Coppabella Wind Farm – Site visit outcomes

Attachment 1: OEH site visit findings from 15 January 2018

Coppabella Wind Farm - Environmental Assessment for Modification One

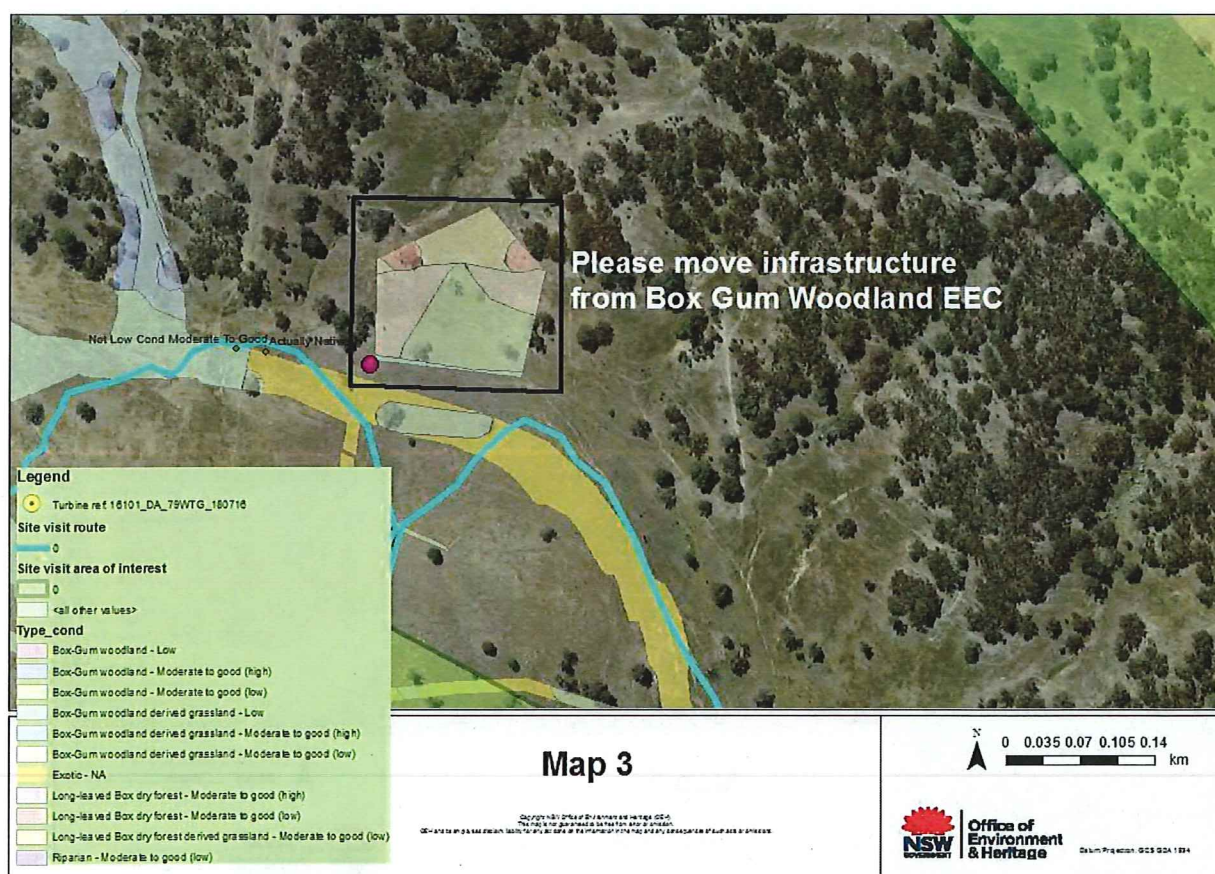
OEH's internal Reference	Easting and Northing GDA94	What the area is currently mapped as	Site inspection finding	OEH's recommended action	Map or photo reference
Photo point FID 3	643560 6151889	Exotic	Confirmed exotic.	None required	n/a
Photo point FID 4	643630 6152117	Exotic	Confirmed exotic.	None required	n/a
Photo point FID 7 – to FID 10	644242 6154023 To 644470 6153861	Exotic	This area is the Box Gum Woodland derived native grassland. NGH agreed on site.	change mapping in this area to Box Gum Woodland derived native grassland (EEC).	Area mapped on Map 1 below.
Photo point FID 13	642206 6154029	This area is mostly mapped as exotic, with small sections of Box Gum woodland - Moderate to good (low) mapped where the trees are.	The trees are close enough to mean the whole area should be mapped as the Box Gum Woodland vegetation moderate to good – the groundcover is also native (not exotic). There is a substantial Yellow Box tree with hollows in this area that should be protected during construction and operation.	Update mapping of this area to Box Gum Woodland (EEC) - moderate to good condition. Move infrastructure into the more degraded areas.	Area mapped on Map 2 below.

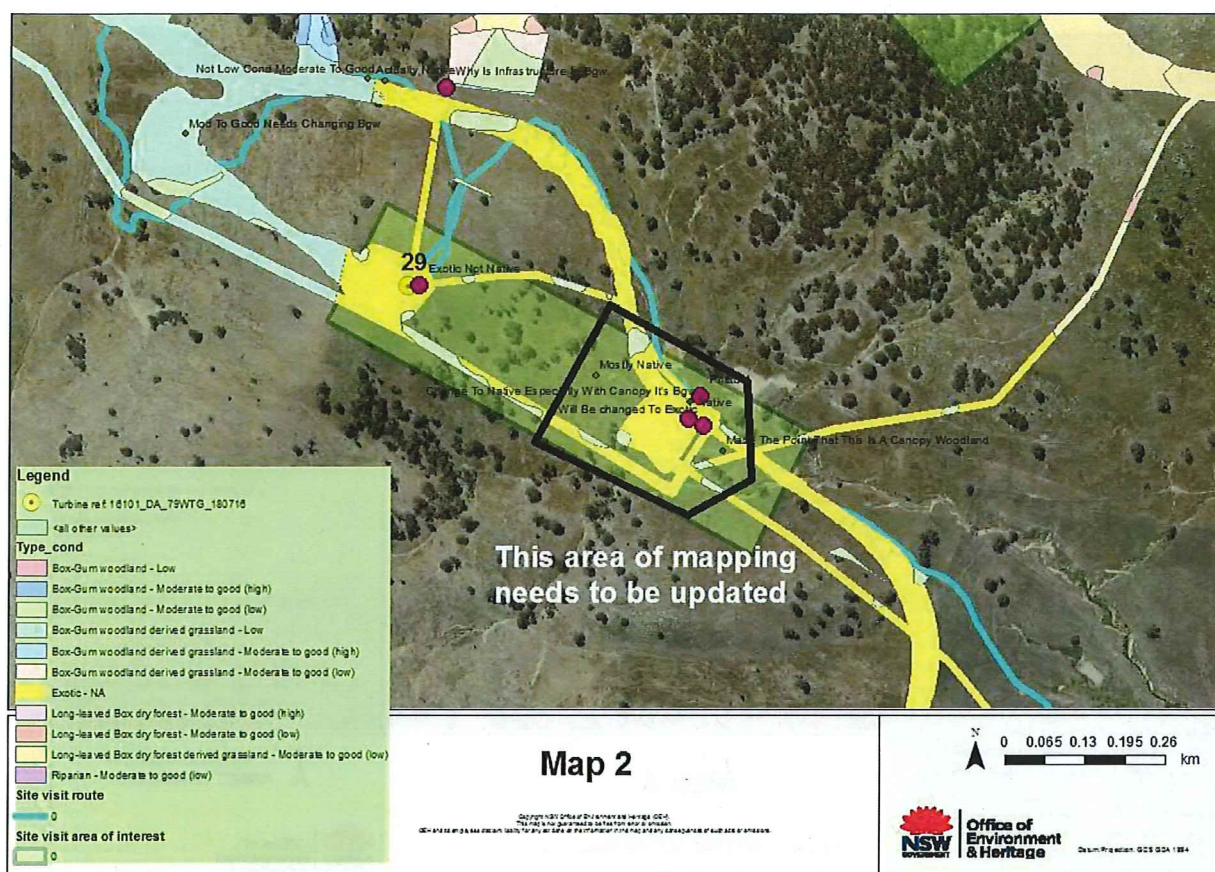
Photo point FID 15	641768 6154245	Exotic	Confirmed exotic.	None required	n/a
Photo point FID 16	641811 6154561	Box Gum woodland - Moderate to good (low) and mix of other.	Infrastructure placed in an area mapped Box Gum woodland - Moderate to good – when there are exotic	Suggest avoiding impact to the Box Gum woodland – EEC and situating the infrastructure in a cleared area.	Area mapped on Map 3 below.

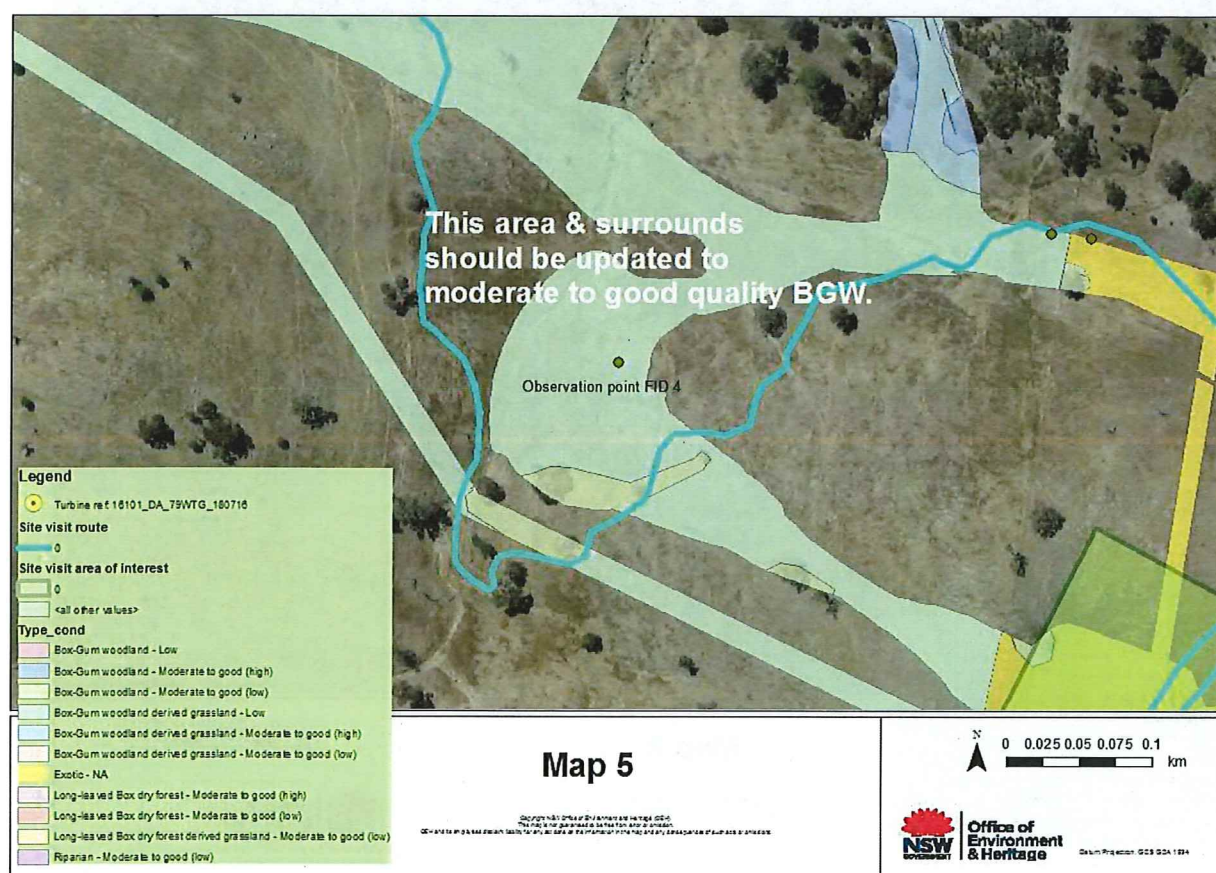
cleared areas surrounding it.		
Observation point FID 2	641712 6154573	Exotic	Over 50% native. This area is the Box Gum Woodland derived native grassland. NGH agreed on site.	Update mapping in this area to Box Gum Woodland derived native grassland (EEC) - Moderate to good condition	Area mapped on Map 4 below.
Observation point FID 3	641685 6154576	Box Gum Woodland derived native grassland - low (exotic)	Over 50% native. Box Gum Woodland derived native grassland - Moderate to good	Update mapping in this area to Box Gum Woodland derived native grassland (EEC) - Moderate to good condition	Area mapped on Map 4 below.
Observation point FID 4	641390 6154488	Box Gum Woodland derived native grassland - low (exotic)	Over 50% native. Box Gum Woodland derived native grassland - Moderate to good	Update mapping in this area to Box Gum Woodland derived native grassland (EEC) - Moderate to good.	Area mapped on Map 5 below.

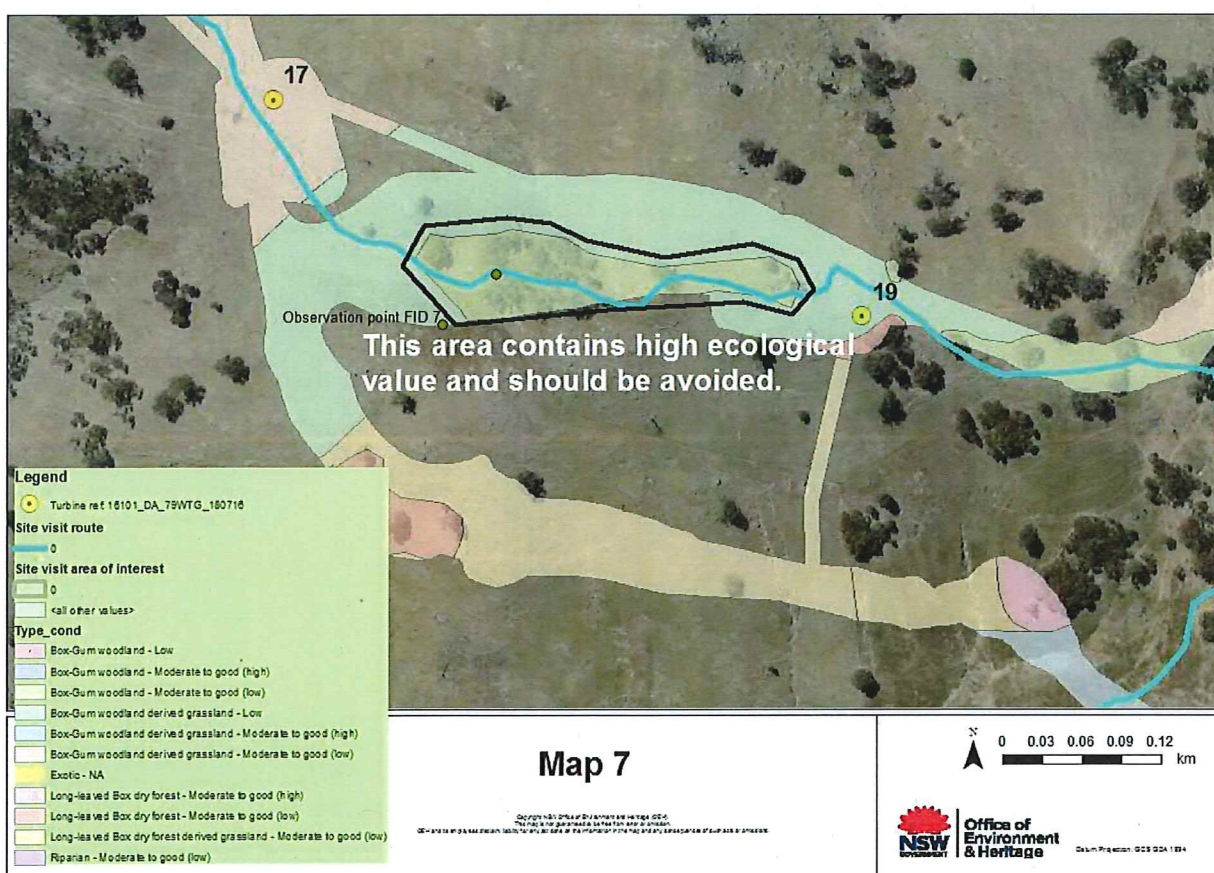
Observation point FID 5	641271 6154734	Box Gum Woodland derived native grassland - low (exotic)	Over 50% native. Box Gum Woodland derived native grassland - Moderate to good	Update mapping in this area to Box Gum Woodland derived native grassland (EEC) - Moderate to good	Area mapped on Map 6 below.
Observation point FID 6	642170 6155321	Exotic	Confirmed exotic.	None required	n/a
Observation point FID 7	640898 6155370	Box Gum woodland - Moderate to good (low)	Likely to meet a higher quality class – very good quality vegetation in this area with a very high number of tree hollows. Sighting of two Wedged-tail Eagles foraging in this area.	Avoid this area of important woodland – moving infrastructure to areas of degraded vegetation surrounding this patch.	Area mapped on Map 7 below.
Photo FID 18	636829 6155380	Exotic	Confirmed exotic.	None required	n/a
Photo FID 19 & 20	638515 6154116	Exotic	Borderline exotic and native. Difficult to tell due to grazing pressure.	None required	n/a
